UNITED STATES
CLEAR REGULATORY COMMISSION
WASHINGTON, D. C. 20555
February 9, 1989

The Commission has issued the enclosed Amendment No. 120 to Facility Operating License No. DPR-58 and Amendment No. 107 to Facility Operating License No. DPR-74 for the Donald C. Cook Nuclear Plant, Unit Nos. 1 and 2. The amendments consist of changes to the Technical Specifications in response to your application dated March 26, 1987 as clarified and supplemented by letters dated August 25, 1987, and June 7 and August 31, 1988. Also, you corrected typographical errors in the original submittal via replacement pages provided to the NRC on January 13, 1988.

These amendments revise the Technical Specifications on boron concentrations; change the moderator temperature coefficient to a ramp function rather than a step function; remove 3-loop operation in Modes 1 and 2; add additional restrictions because of safety analyses; add footnotes such that addition of water from the RWST does not constitute a boron dilution; clarify trip channel positions for different pressure between steam lines in 3-loop operation; require two PORV's be available in Modes 1, 2, and 3; add 4.0.4 and 3.0.4 section exemptions;

Figure 3.1-3 REQUIRED SHUTDOWN MARGIN

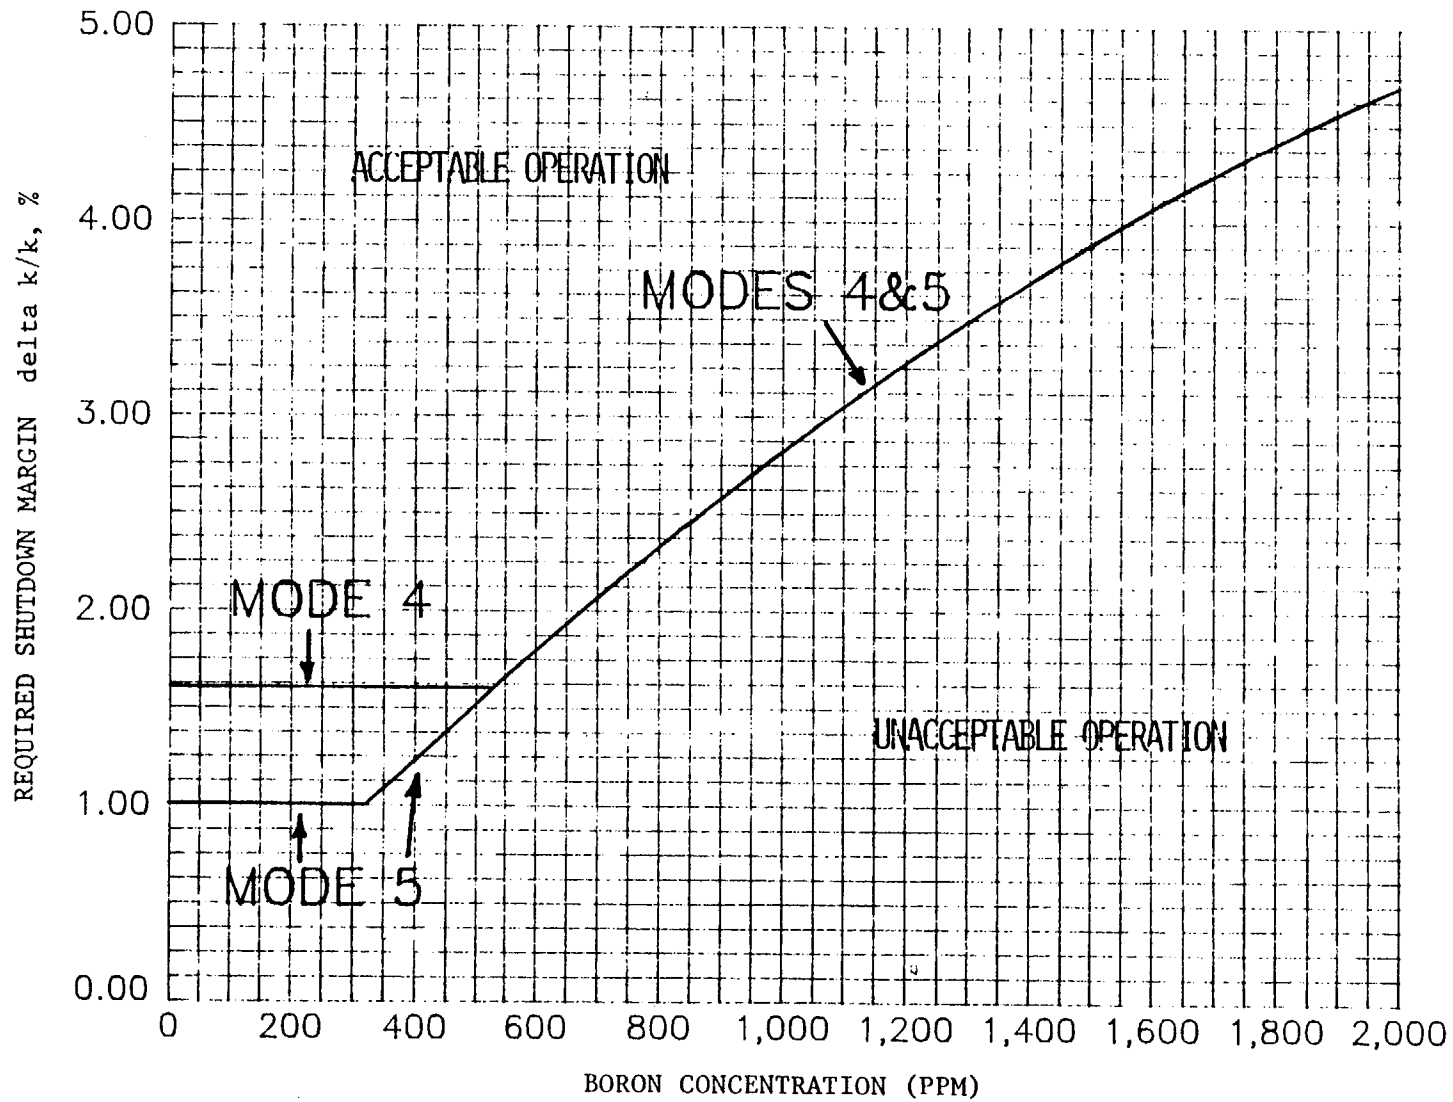
2.1	Mathematical symbols are written out in words.
		2.1	Specification title is changed.
3/4 1-3a	4.1.1.2.b	2.1	Specification 4.1.1.2.b is moved to new page 3/4 1-3a.
3/4 1-3b	Figure 3.1-3	2.1	New figure is added.
3/4 1-3a; 3/4 1-3b		2.1	Pages added due to length of new specification.
3/4 1-4	3.1.1.3 4.1.1.3	2.1	"reactor pressure vessel" is changed to "reactor coolant system".

FIGURE 3.1-1 ROD GROUP INSERTION LIMITS VERSUS THERMAL POWER 4 LOOP OPERATION

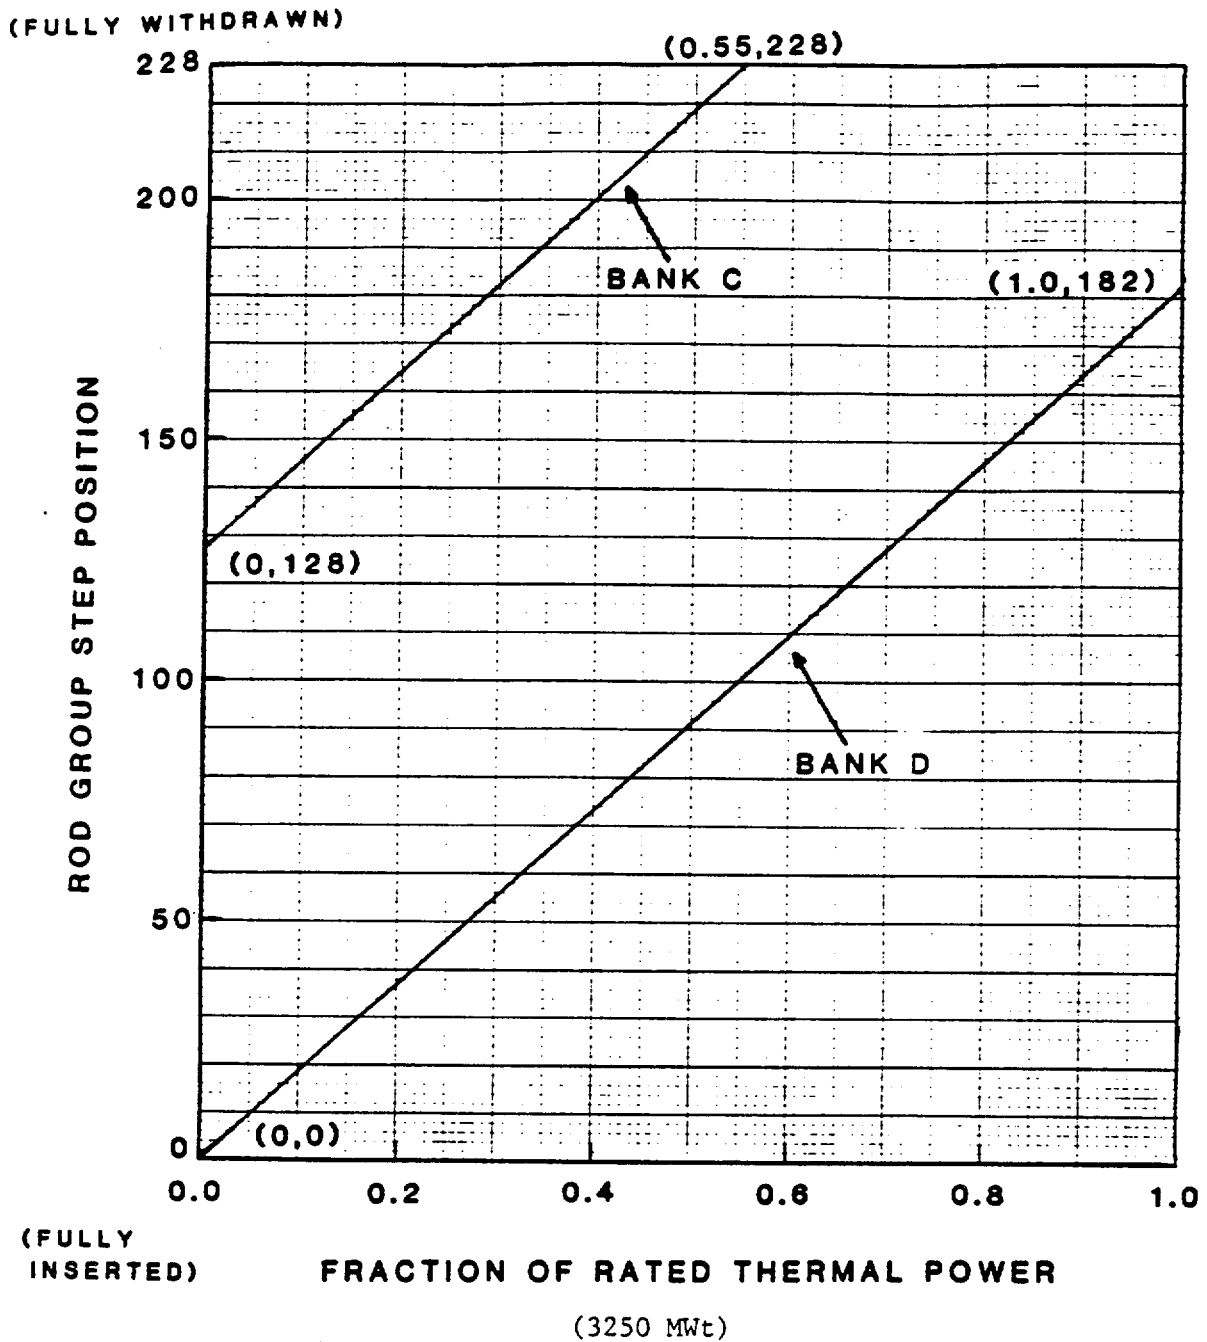
2.1	Mathematical symbols are written out in words.
3/4 1-24; 3/4 1-25; 3/4 1-26	Figure 3.1-1 Figure 3.1-2	2.1	Rod Group Insertion Limits figure for 4 Loop Operation is redrawn with labeled endpoints.

PAGE	SECTION	SER SECTION	DESCRIPTION
		2.2	Rod Group Insertion Limit figure for 3 Loop Operation is removed.
		2.1	Rod Group Insertion Limit figure for 4 Loop Operation is renamed Figure 3.1-1.

FIGURE 3.2-1 ALLOWABLE DEVIATION FROM TARGET FLUX DIFFERENCE

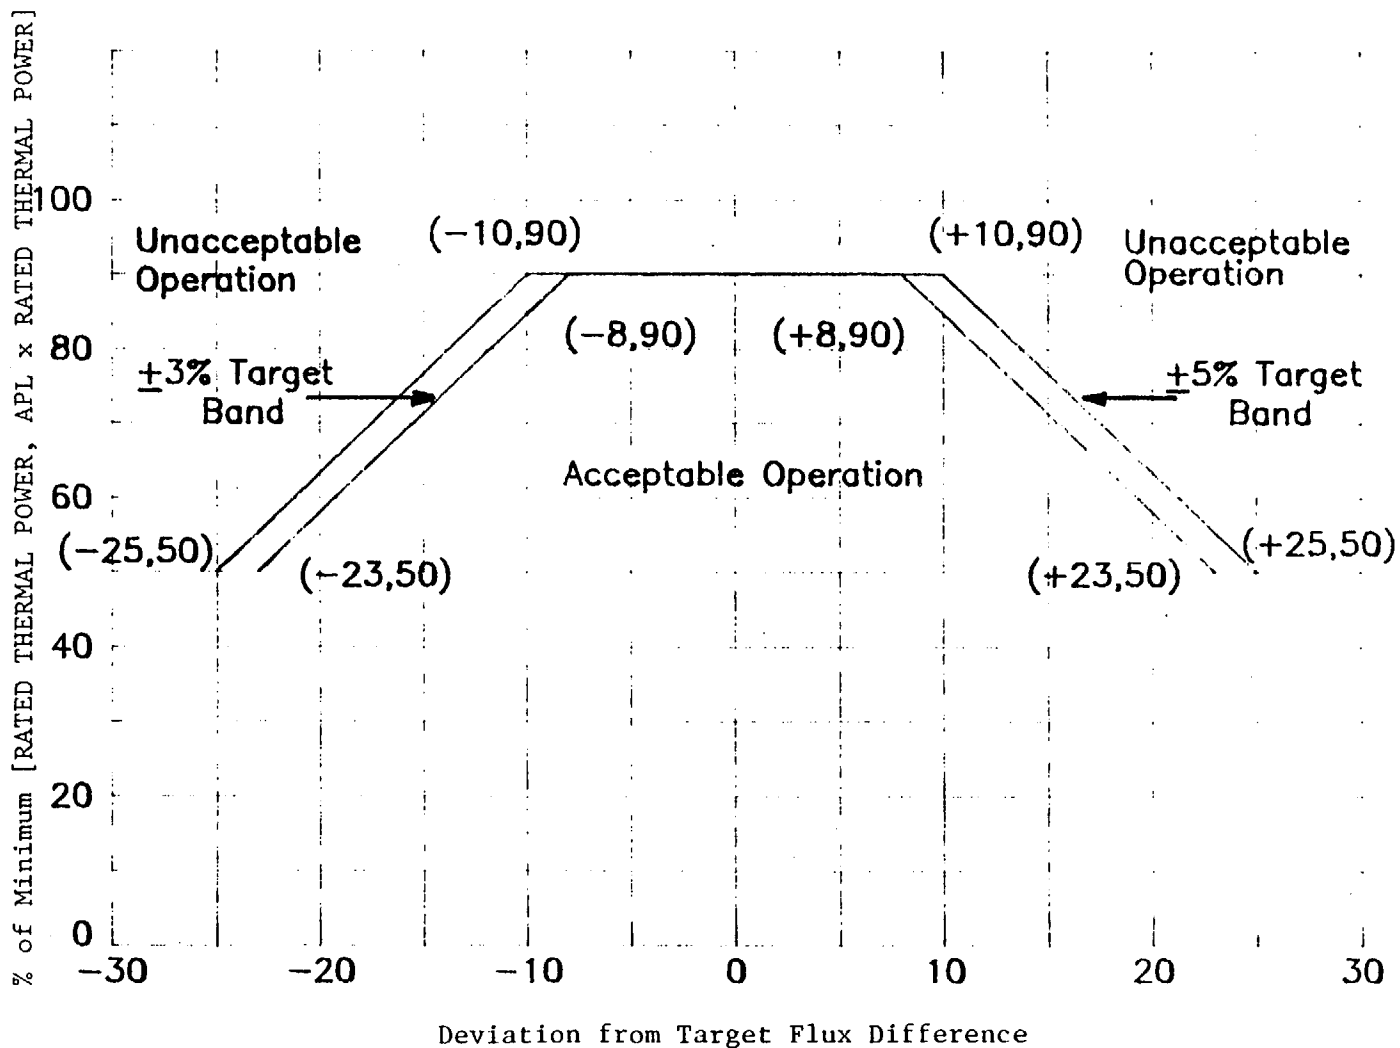
3.2.1.d	2.1	Action d is removed.
3/4 2-3	4.2.1.3 4.2.1.4	2.10	$F_Q^M(Z)$ is changed to APL. Referenced specification number has changed.
3/4 2-4	Figure 3.2-1	2.1	Figure is redrawn.
3/4 2-5	3.2.2	2.1	Description of $F_Q(Z)$ penalties moved from surveillance to LCO.
3/4 2-5	3.2.2	2.10	The F_Q limit for Exxon fuel is changed to fixed value of 2.04.

FIGURE 3.2-2 EXXON FUEL
K(Z) NORMALIZED VS. CORE HEIGHT

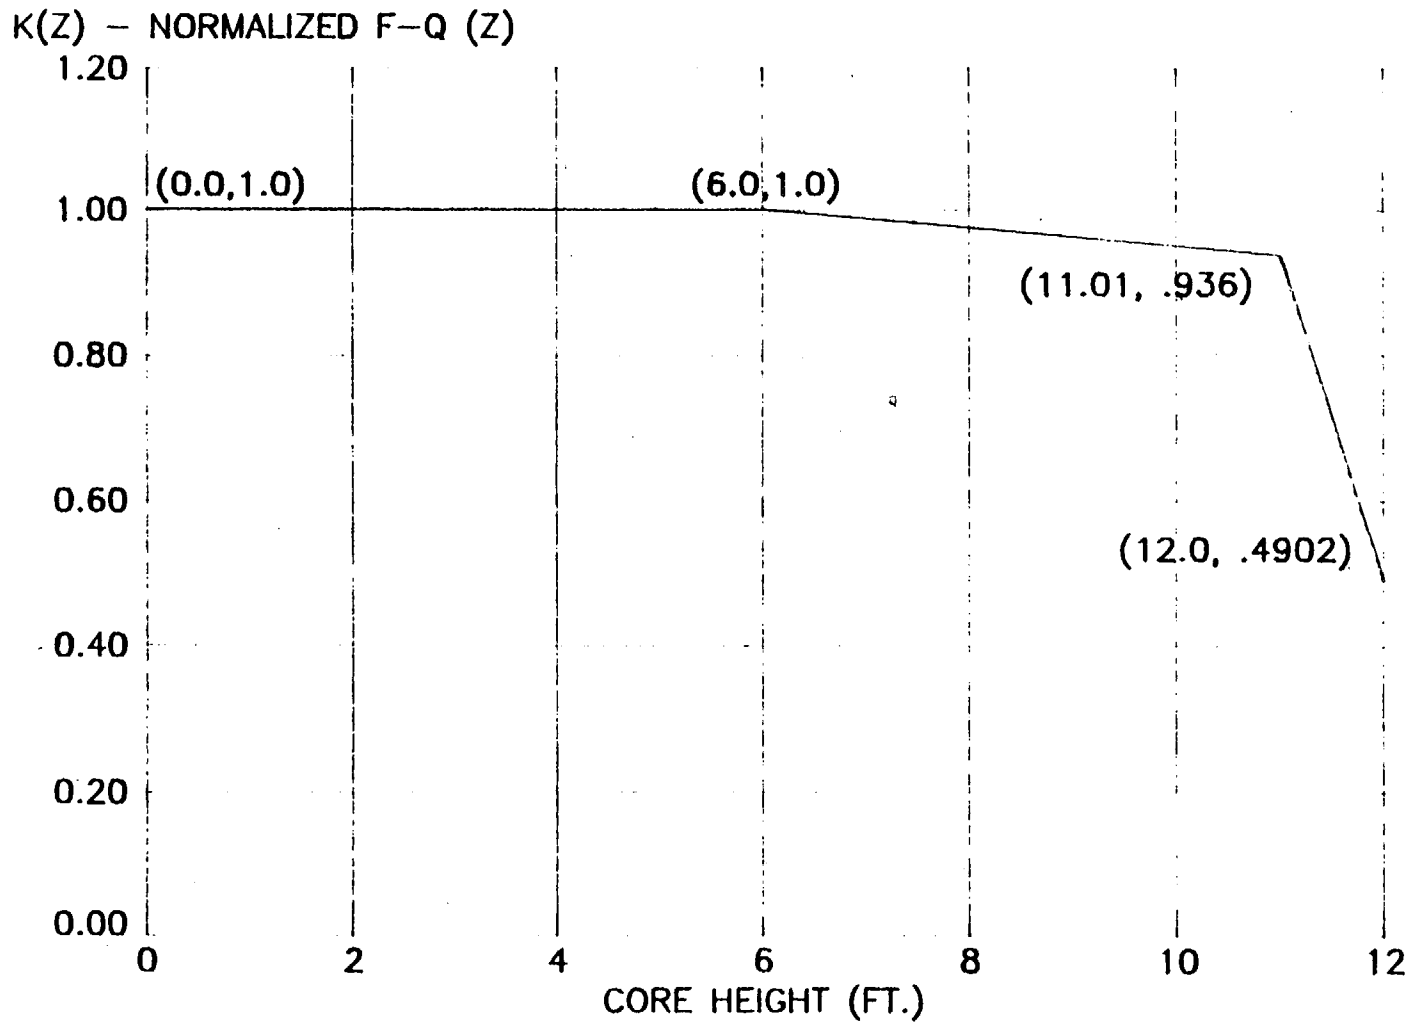
PAGE	SECTION	SER SECTION	DESCRIPTION
3/4 2-5; 3/4 2-6	3.2.2	2.1	ACTION statement b is moved from page 3/4 2-6 to page 3/4 2-5.
3/4 2-6; 3/4 2-7; 3/4 2-8; 3/4 2-9	4.2.2.2	2.10	Much of this surveillance requirement has been moved to APL Specification 3.2.6.
3/4 2-8(a)	Figure 3.2-3	2.1	The V(Z) function provided by Exxon Nuclear Co. is removed from Technical Specifications. This page is to be removed from T/S.
3/4 2-10	Figure 3.2-2	2.1	The figure is redrawn.

FIGURE 3.2-3 WESTINGHOUSE FUEL
K(Z) NORMALIZED VS. CORE HEIGHT

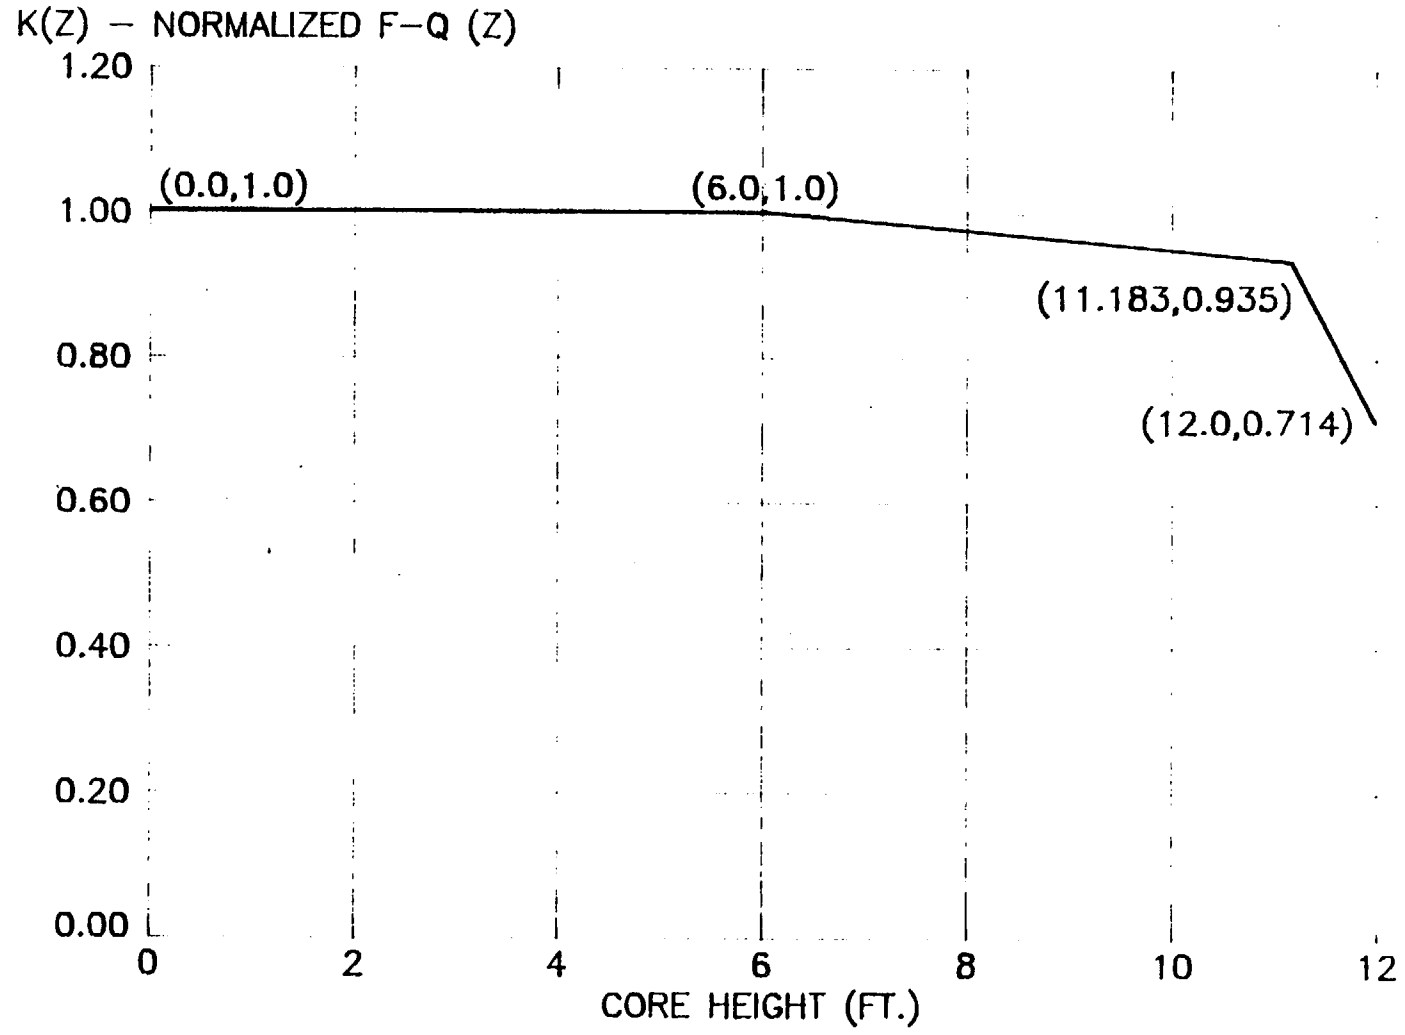
2.1	The page number is changed to 3/4 2-7.
3/4 2-11	Figure 3.2-3	2.1	The figure is redrawn.
		2.1	The page number is changed to 3/4 2-8.
3/4 2-12	3.2.3	2.1	Mathematical symbols are written out in words.

FIGURE 2.1-1 Reactor Core Safety Limits -
Four Loops in Operation

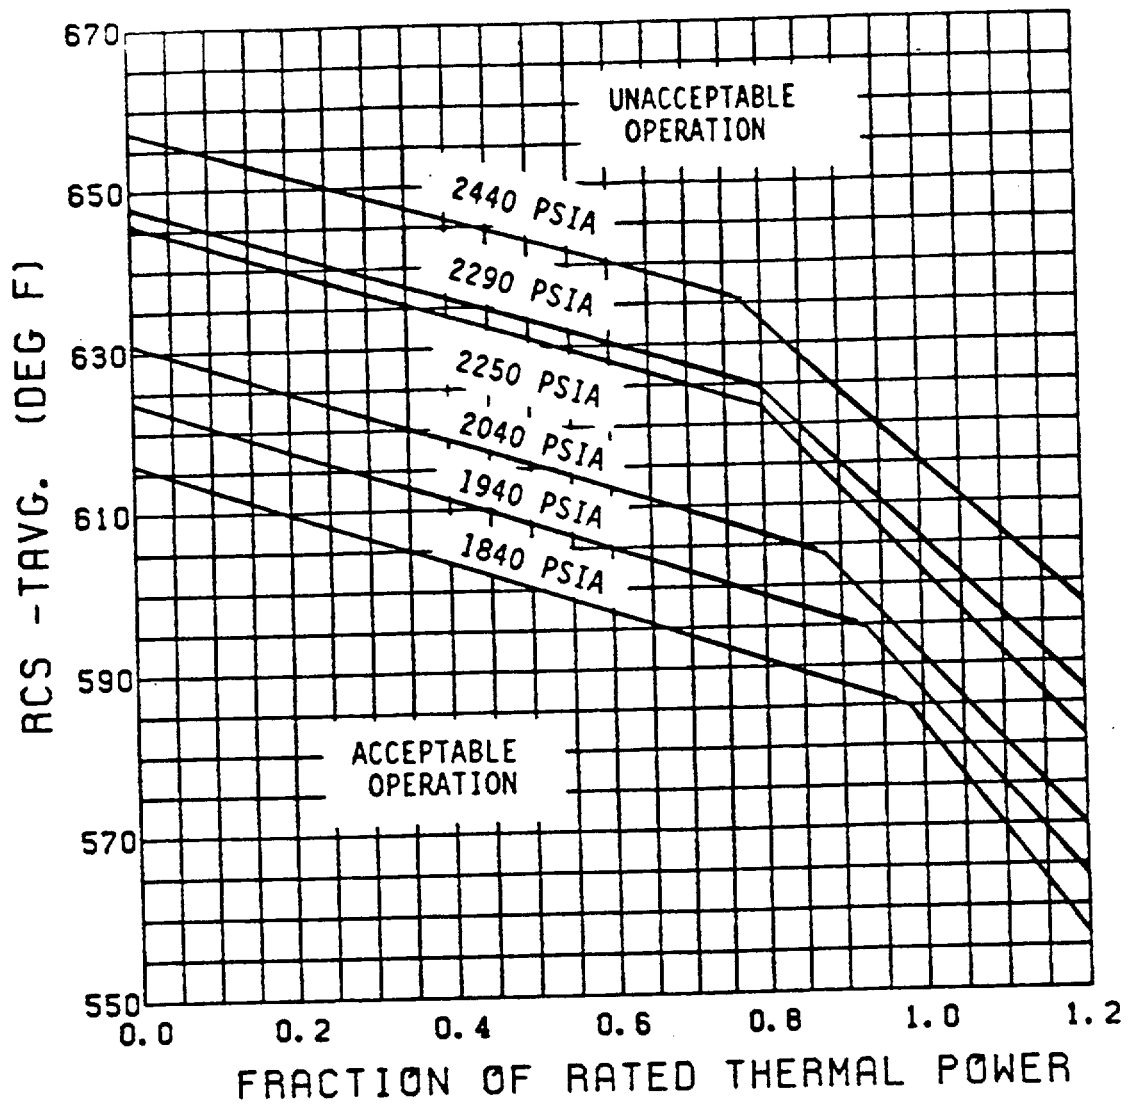
PAGE	SECTION	SER SECTION	DESCRIPTION
2-2	Figure 2.1-1	2.1	Curve for 2250 psia is added.
3/4 1-3	4.1.1.2	2.1	Change "greater than" to "greater than or equal to".

FIGURE 3.1-2 Moderator Temperature Coefficient (MTC)

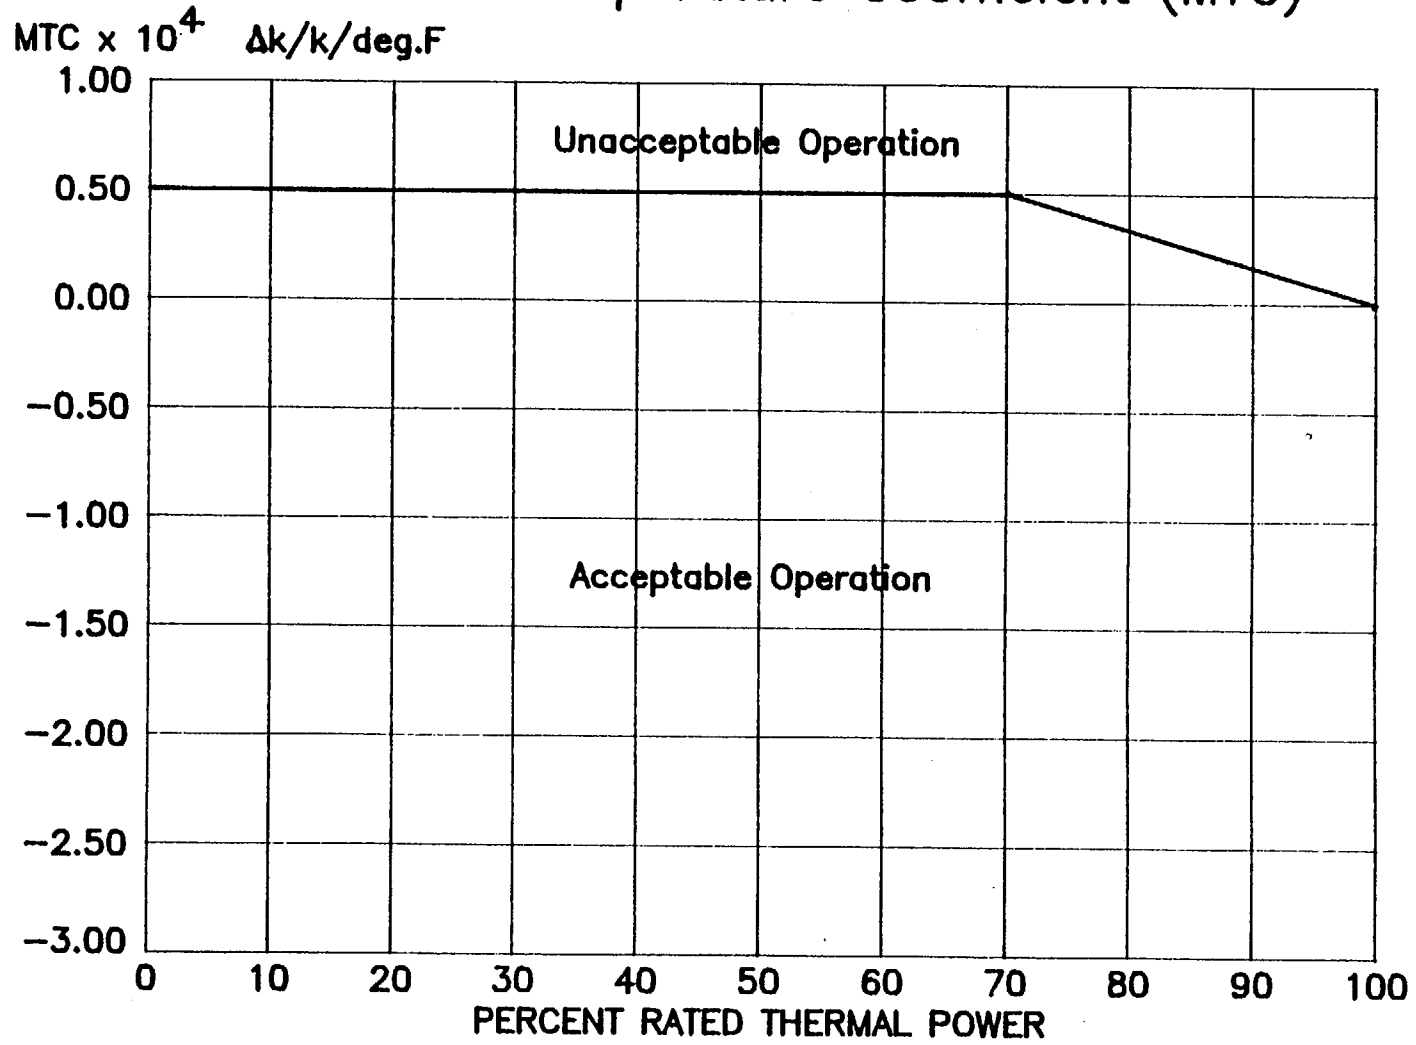
2.1	Mathematical symbols are written out in words.
		2.1	Period added.
3/4 1-4	3.1.1.3	2.8	Flow rate requirement reduced to 2000 gpm.
	4.1.1.3	2.1	Mathematical symbols are written out in words.
3/4 1-5; 3/4 1-6; 3/4 1-6a	3.1.1.4	2.8	The upper limit on MTC for operation above 70% RTP is changed. The upper limit is now graphically displayed.
	Figure 3.1-2

4.1.1.4.b	2.1	Specified 300 ppm surveillance at "RATED THERMAL POWER equilibrium boron concentration".
		2.1	Mathematical symbols are written out in words.
3/4 1-8	3.1.2.1	2.1	The new MTC limits are now graphically displayed in Figure 3.1-2 on new page 3/4 1-6a.
